Rapiscan systems Measurement	Secure 1000 Radiation Emission Measurement	FORM R-0646-1 (Single Pose)
---	---	--------------------------------

Re: Rapiscan AIT System Radiation Survey Reporting

R-0646-1 Addendum (Documentation Errors)

Product Name	Secure 1000SP (Single Pose)
Serial Number	S51009008
Radiation Emission Measurement	Radiation Survey Dated: 07/01/2010
RSO Initials

1. In Beam Dose Measurement: Survey Table. 1

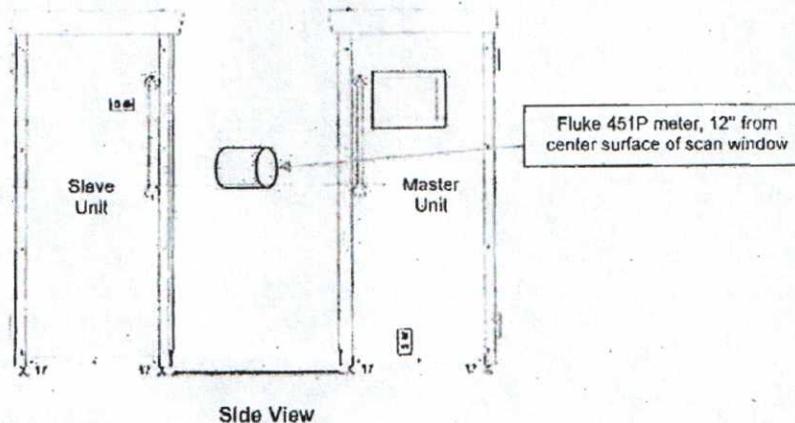
1. No value indicated for background radiation. Typical values range from 7uRem/hr to 13uRem/hr at sea level. Note: Absence of value has no adverse impact on calculations.
2. TABLE 1: Incorrect presentation of data in Column 3 for Measured Exposure. Indicated values are 19uR and 17uR. Corrected values are 1.9uR and 1.7 uR. The values were corrected by technician when calculating Effective Dose.

The service technician should attend refresher training.

The corrected data indicates this system was operating within expected parameters. No re-survey is required for this system.
